HAY CREEK HULL SUBDIVISION

STREET IMPROVEMENT PLAN

# V1\_Construction Drawings (Plans-Profiles)\_comments.pdf Markup Summary

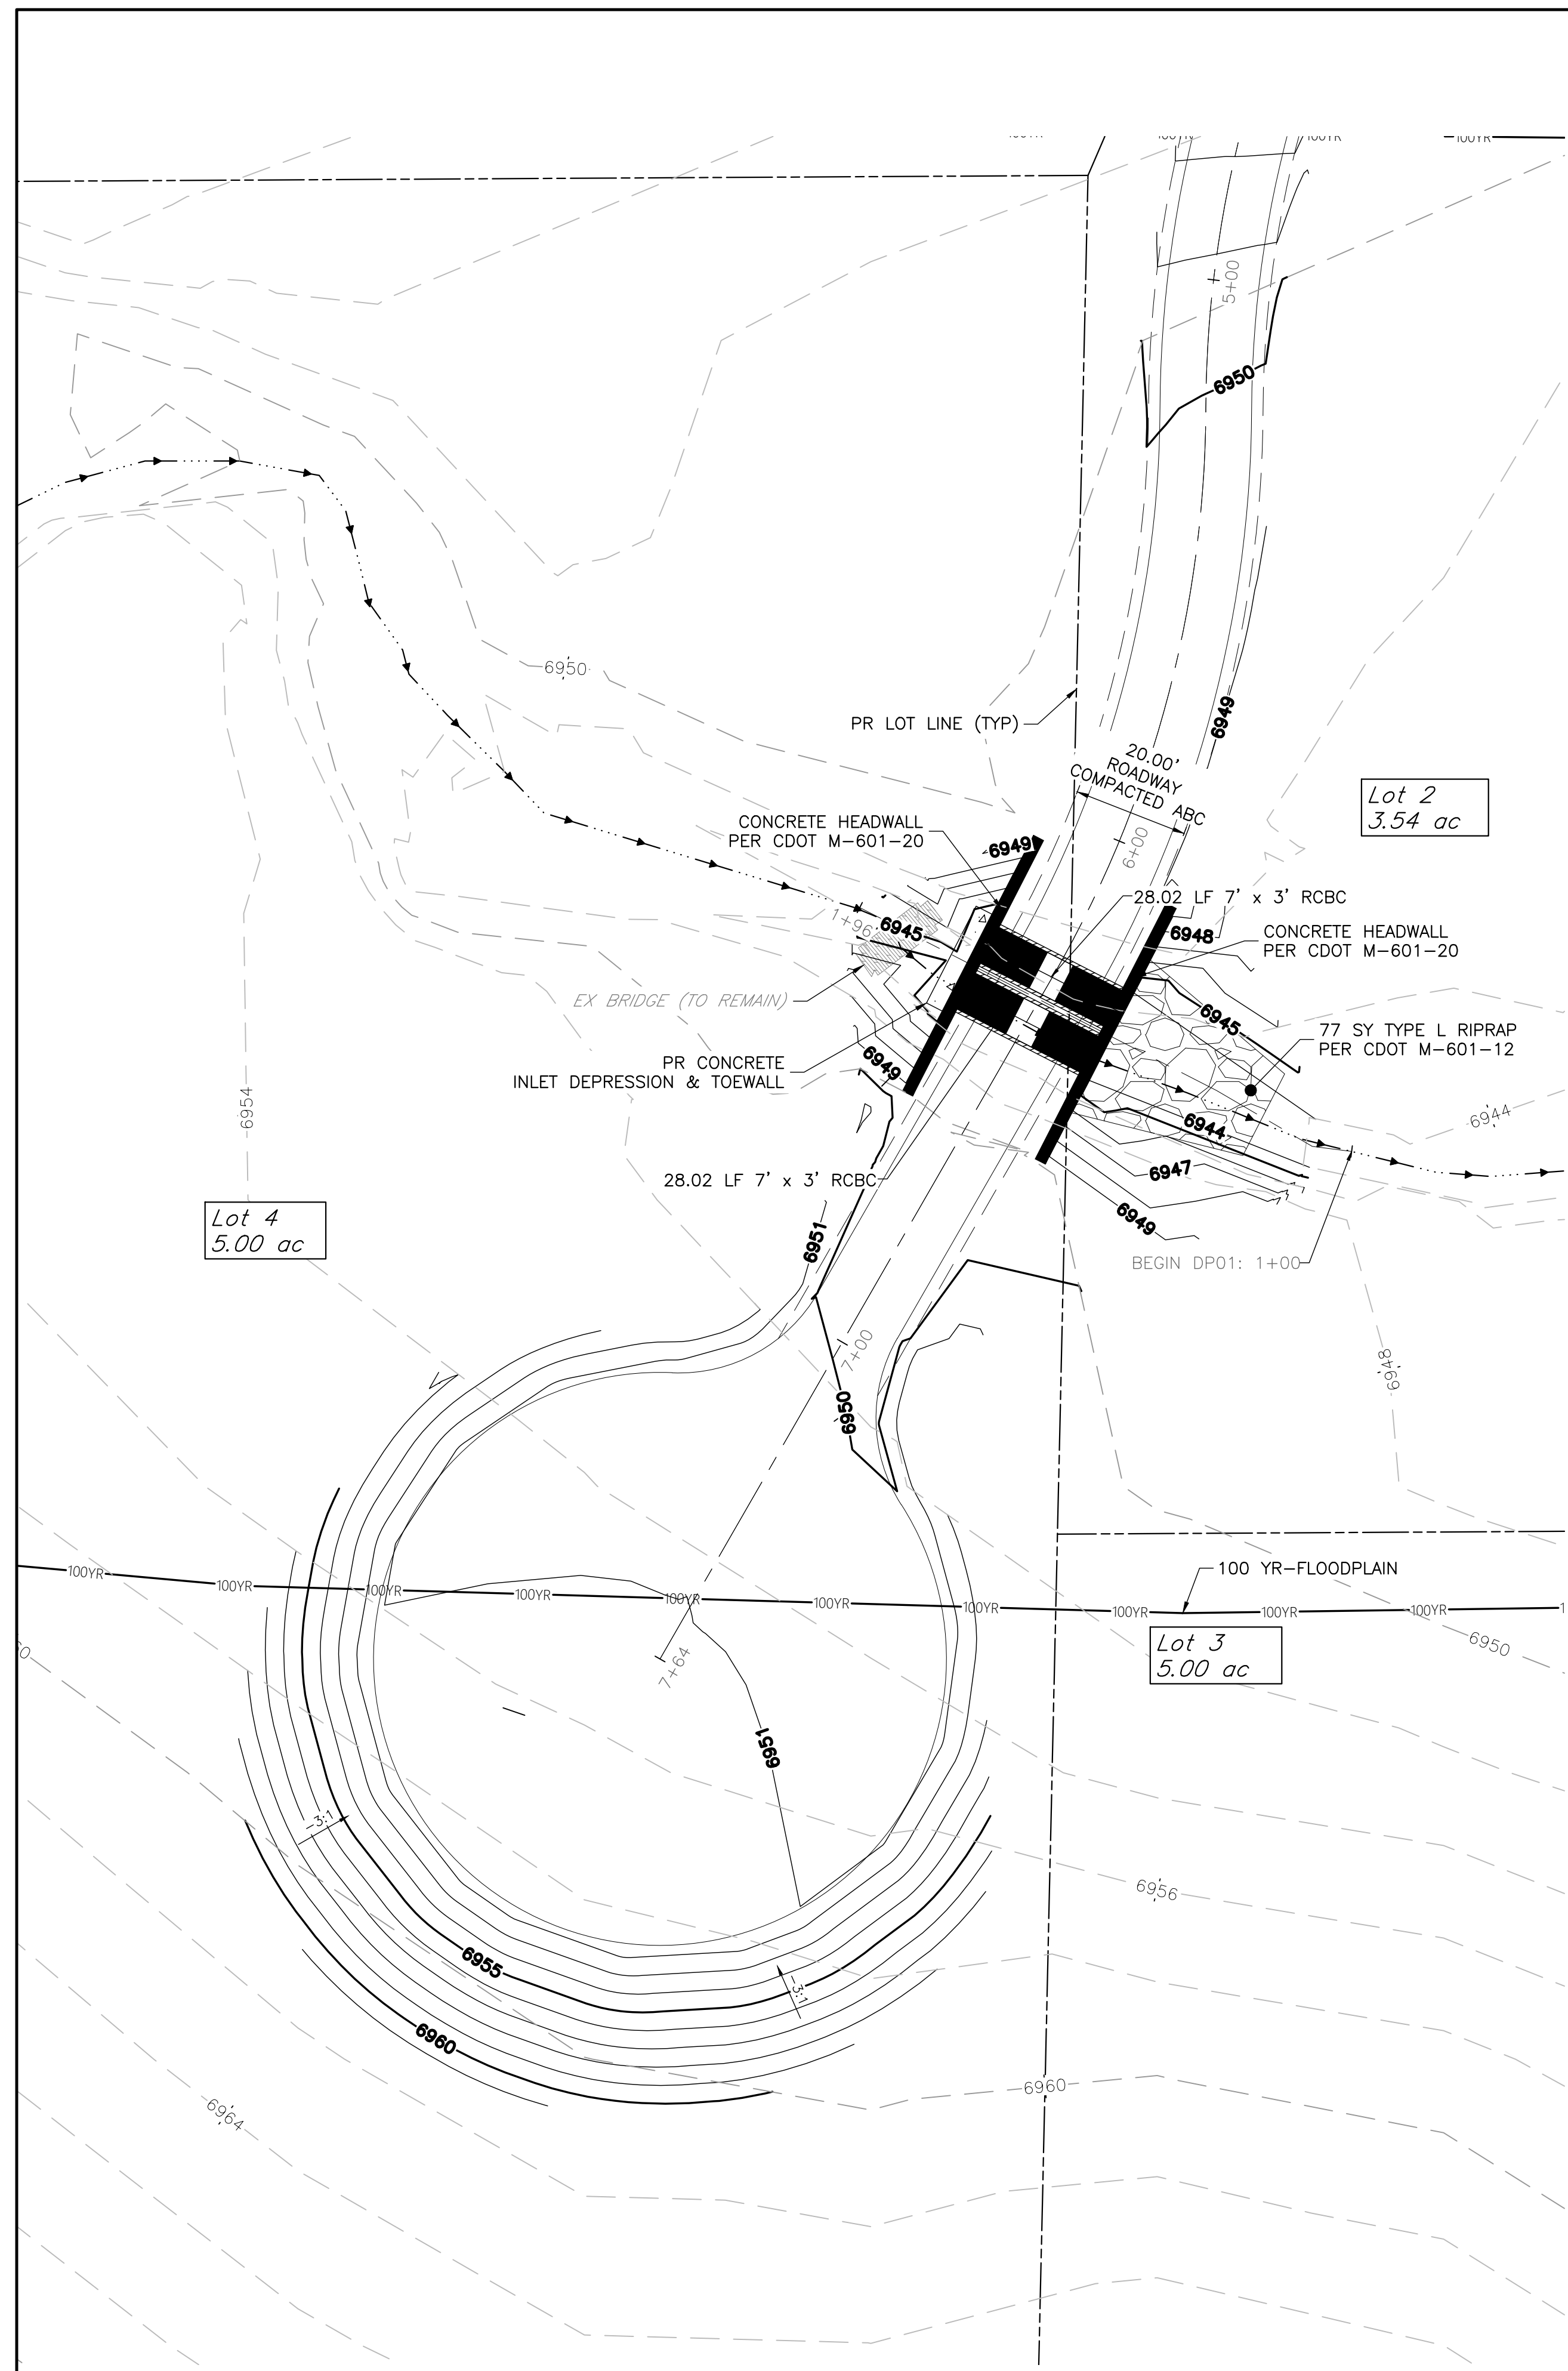
Per LDC, max 3 lots to a driveway. This shall be a roadway. It shall meet County roadway standards (Rural Local roadway classification). Please revise the roadway, detail, and profile accordingly.

If deviating from ECM criteria, please submit deviation request form for consideration by the ECM administrator.

Please identify the design speed and ensure K value is met per ECM table 2-14, & figure 2-20

Vertical curve required.

Refer to EPC standard detail 2-76 for cul-de-sac radii requirements

min. 200' per ECM 2.3.3.F.3

identify the roadway classification and design speed.

provide sight distance analysis per ECM 2.3.6

exceeds max. grad per criteria. revise

provide vertical curve

provide stop sign and epc private street name sign

R=300' per rural local roadway standards

HAY CREEK HULL SUBDIVISION  
STORM SEWER PLAN & PROFILE

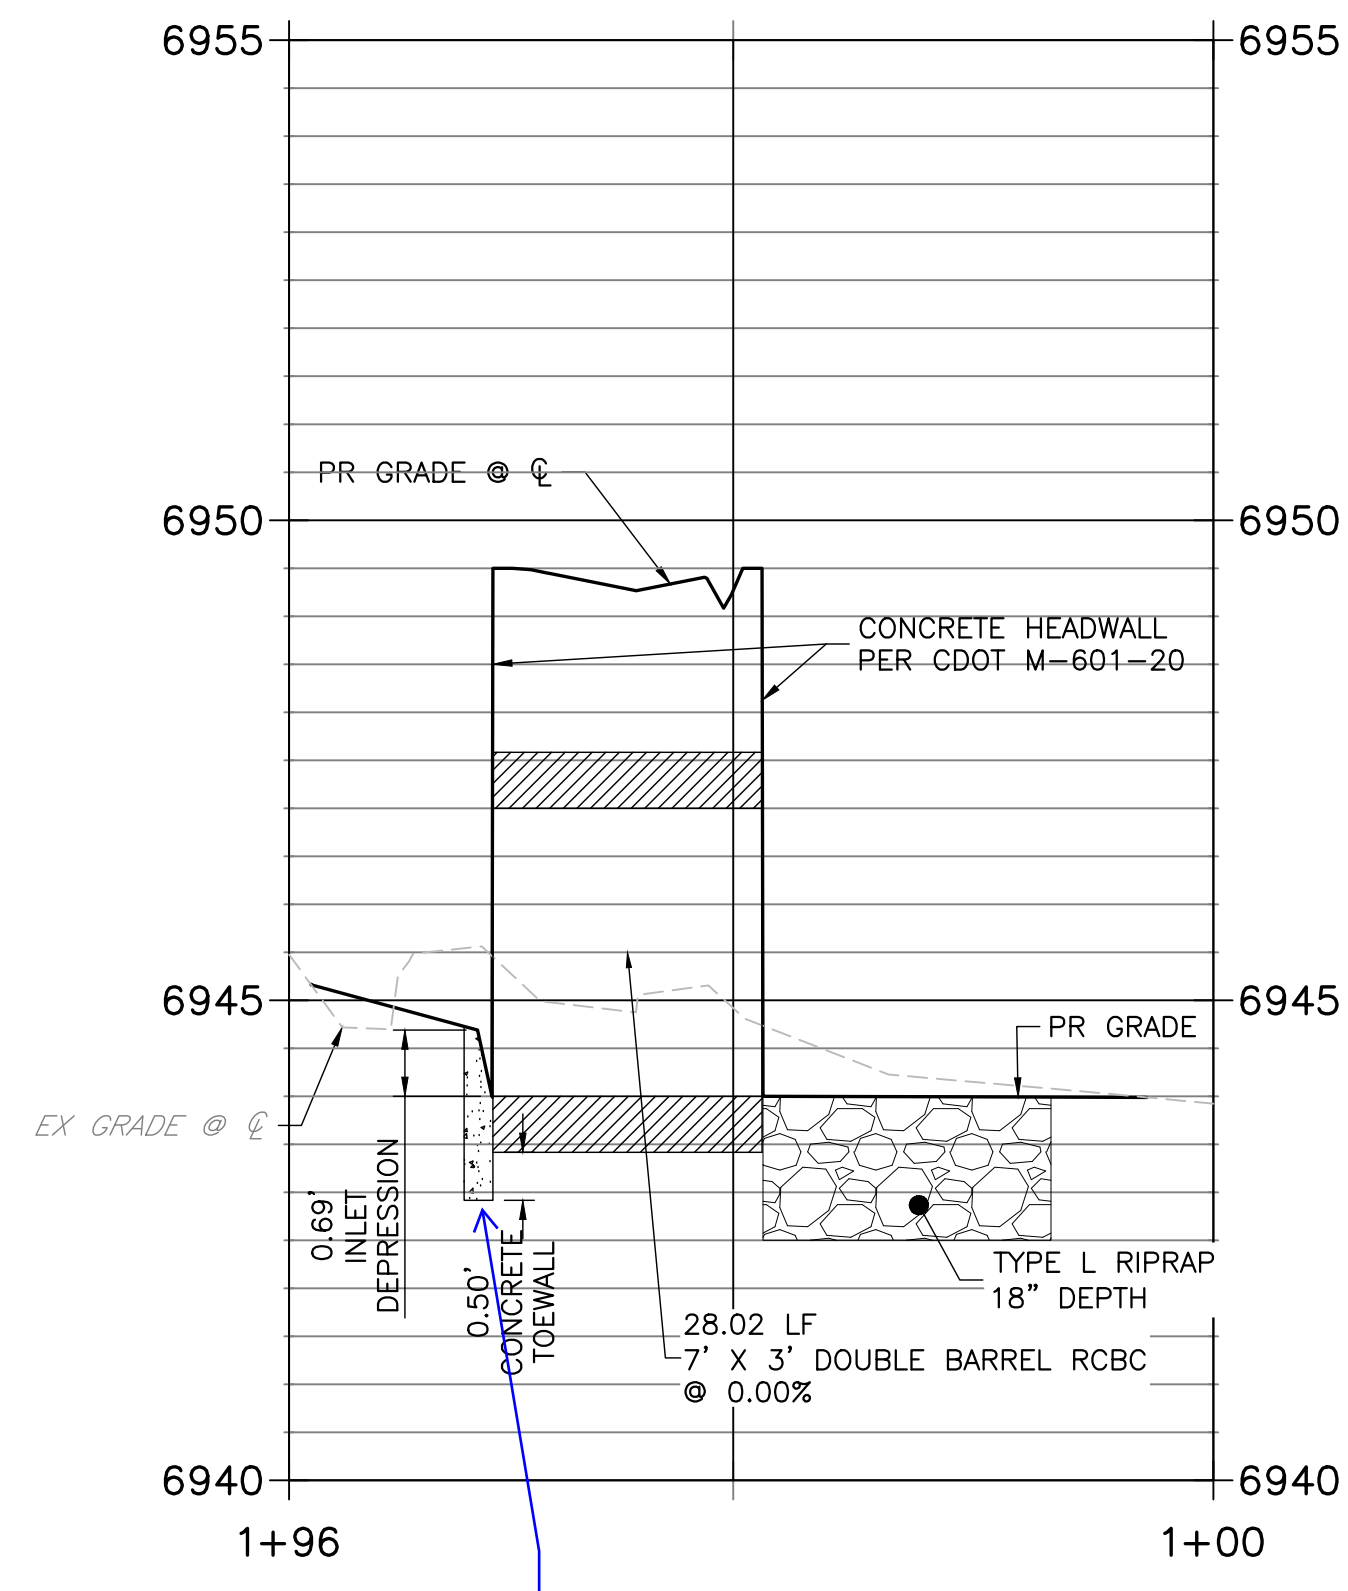
provide detail for toewall
